Accessibility Survey

City of Downey Downey Avenue & De Palma Street

Date of Inspection
1/31/2017

Prepared By
Disability Access Consultants
(800) 743-7067

Change In Level South Of 6th Street @ 33.943968518462, -118.130208849907

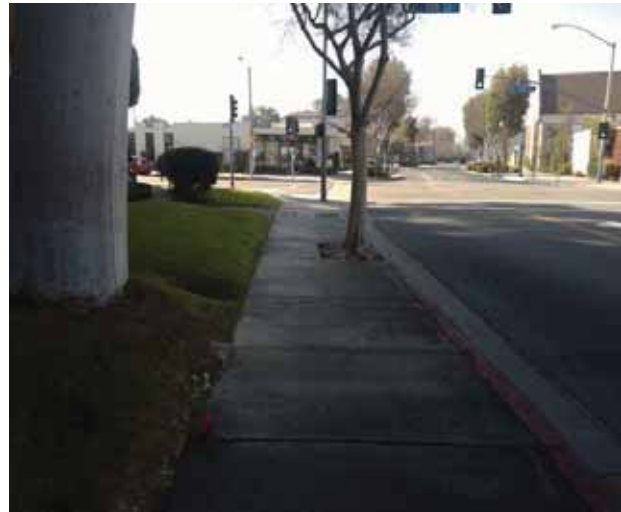
There is a change in elevation greater than recommended value.

On-Site Finding 0.62 inches

Ensure that the change in elevation is within the recommended value.

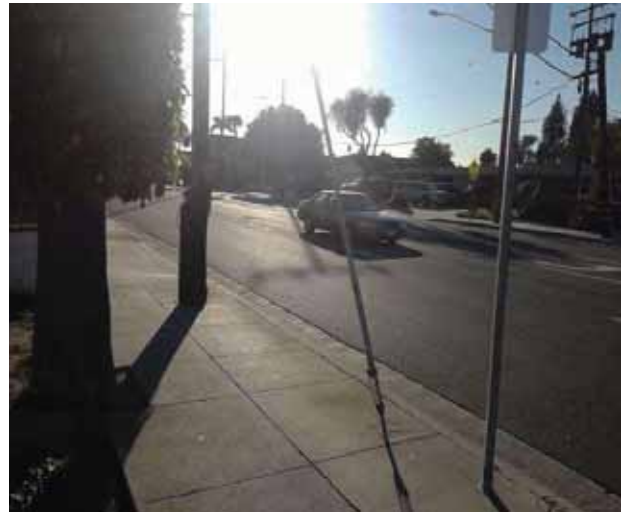
Overhead obstruction height is not compliant.

On-Site Finding 60.00 inches

Provide a compliant vertical clearance height.

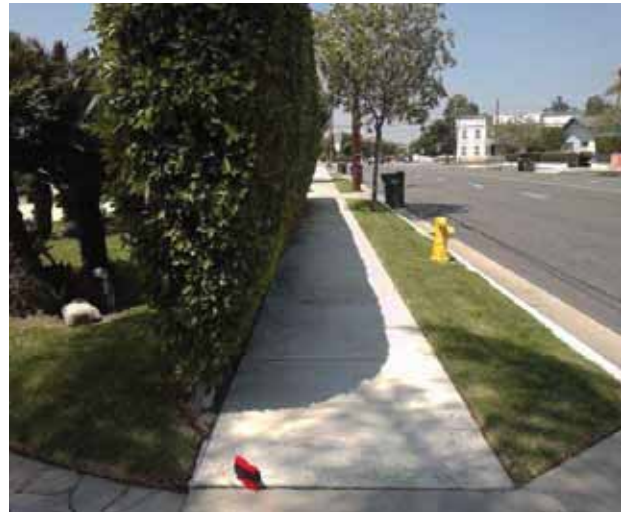
There is a change in elevation greater than recommended value.

On-Site Finding 0.62 inches

Ensure that the change in elevation is within the recommended value.

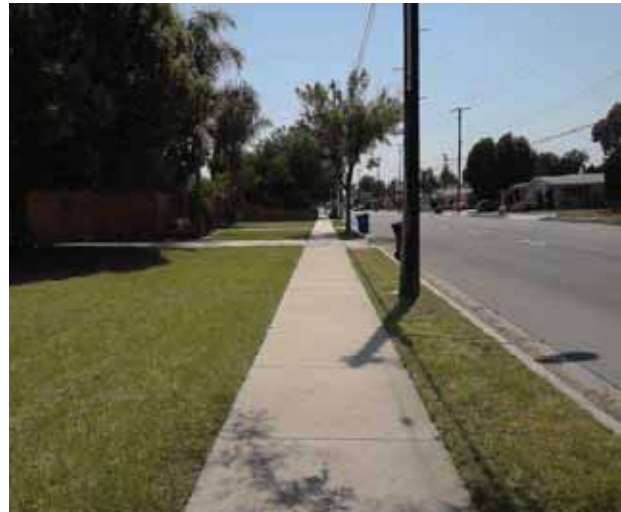
Sidewalk cross slope is not compliant.

On-Site Finding 3.60 percent for 58.00 feet

Repave the sidewalk surface with the recommended cross slope.

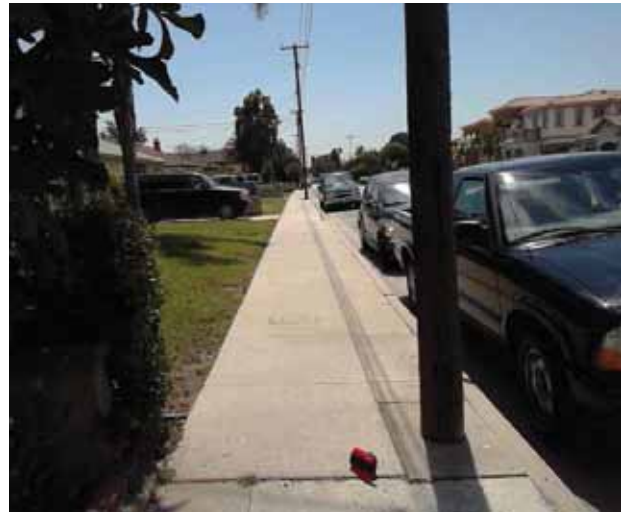
There is a change in elevation greater than recommended value.

On-Site Finding 0.62 inches

Ensure that the change in elevation is within the recommended value.

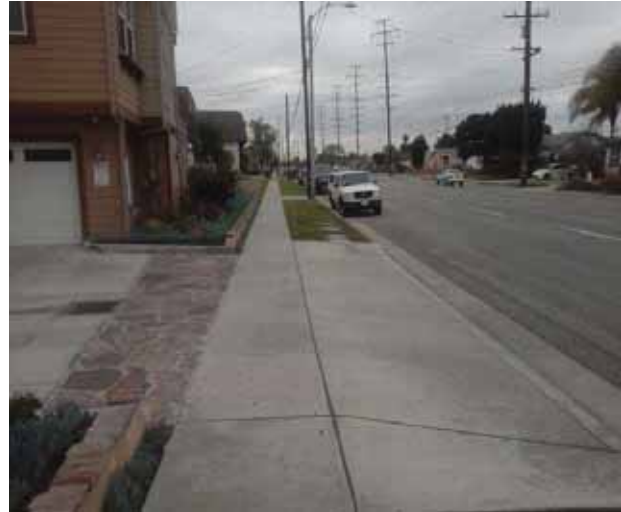
There are no detectable warnings where the pedestrian route crosses vehicular traffic.

On-Site Finding Not Found

Provide detectable warnings.

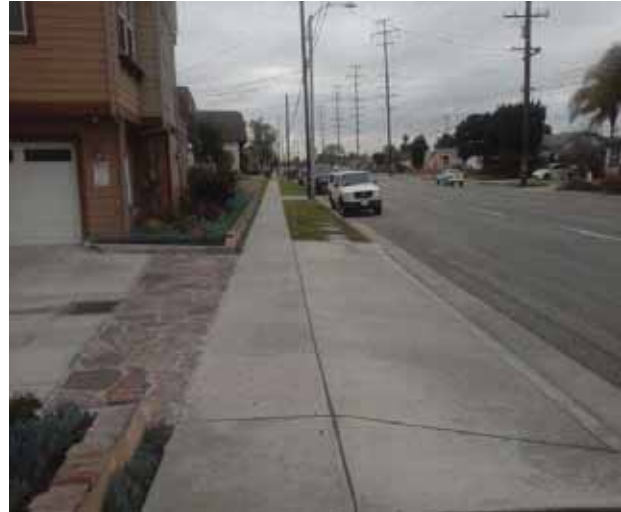
Cross slope at vehicular traffic is not compliant.

On-Site Finding 3.90 percent

Repave the surface to provide a compliant cross slope.

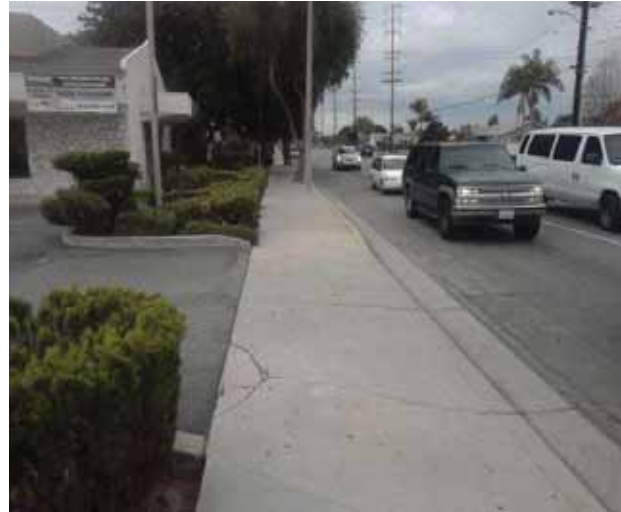
There is no 60X60 turn area at every 200 feet.

On-Site Finding Not Found

Provide a 60X60 turn every 200 feet on the sidewalk.

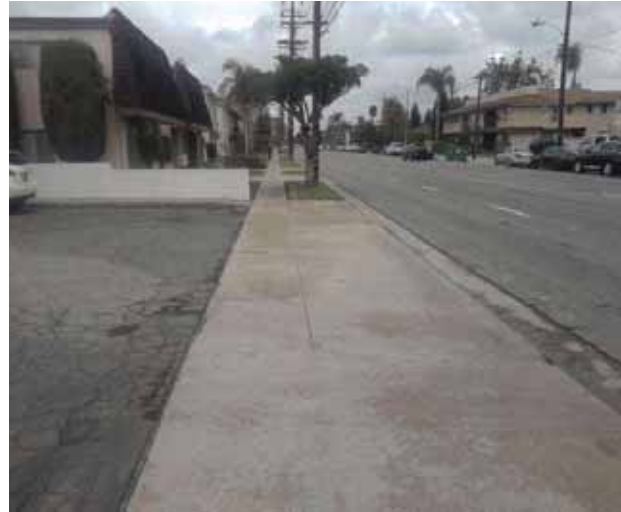
Cross slope at vehicular traffic is not compliant.

On-Site Finding 8.00 percent

Repave the surface to provide a compliant cross slope.
